APICAL INDUSTRIES, INC.
dba DART AEROSPACE

ENGINEERING CHANGE NOTICE NO.

05397

DWG TITLE: STRUT ASSY

SHEET 2, ZONE D4 IS:

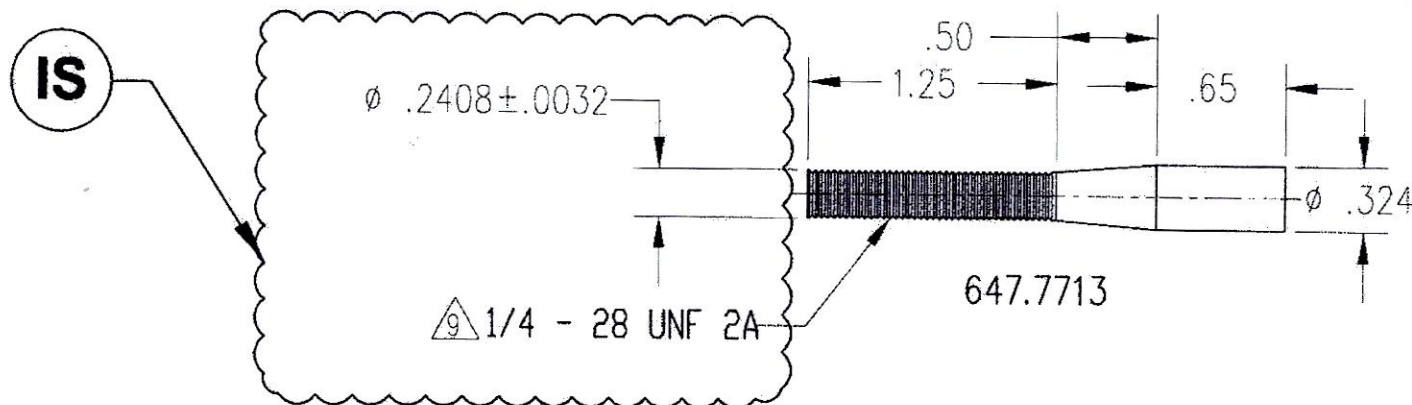
REASON: REVISED DIMENSION

SHEET 1, NOTES IS:

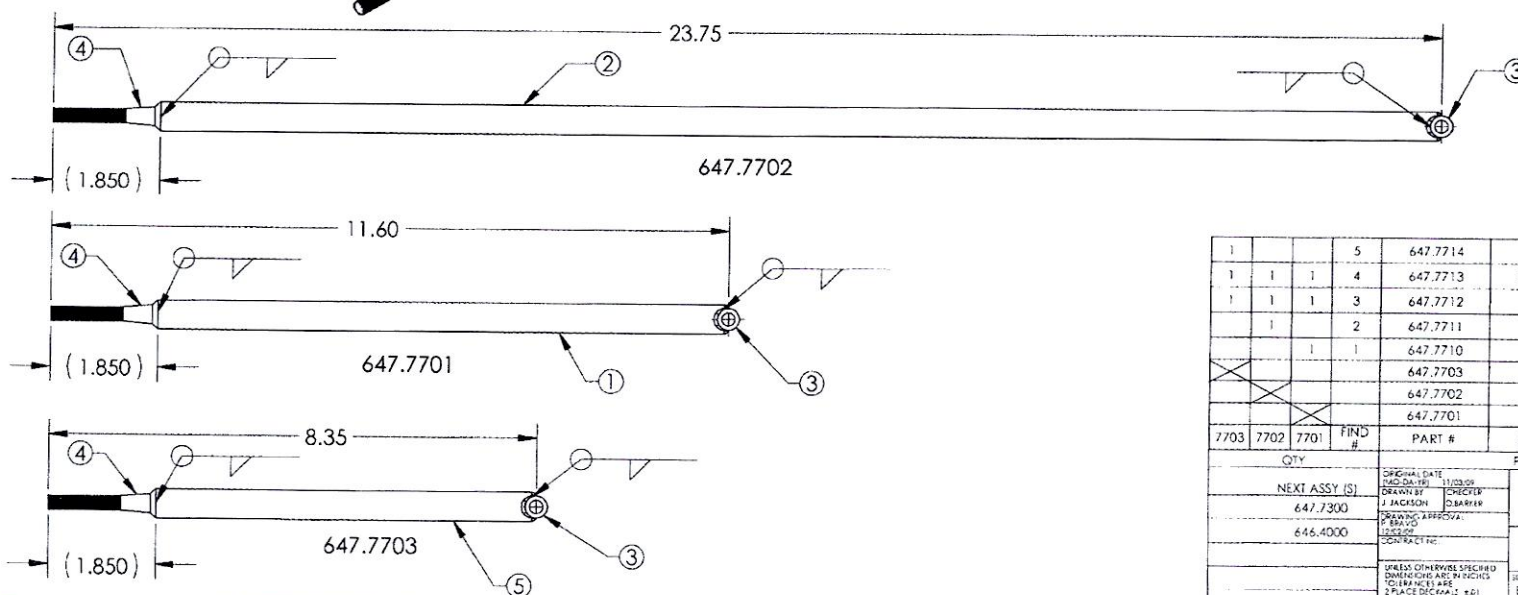
REASON: REVISED FINISH CALLOUT AS PER ECR 15-209

- 1 MATERIAL: 4130 STEEL PER AMS-T-6736, .50" OD, .083" WALL THK.
- 2 MATERIAL: 4130 STEEL PER AMS-T-6736, .375" OD, .075" WALL THK.
- 3 MATERIAL: 4130 STEEL PER AMS-T-6736, .324" OD.
- 4 FINISH: PRIME IAW MIL-P-2337J TYPE I CLASS N; 1-2 MIL MAX
5. DEBURR AND BREAK ALL SHARP EDGES
6. IDENTIFY IAW MPP-120.
- 7 WELD IAW MIL-STD-2219. TIG WELD WITH FILLER ROD
- 8 FINISH: CAD PLATE IAW QQ-P-416F CLASS I TYPE II
- 9 MASK THREAD PRIOR TO FINISH
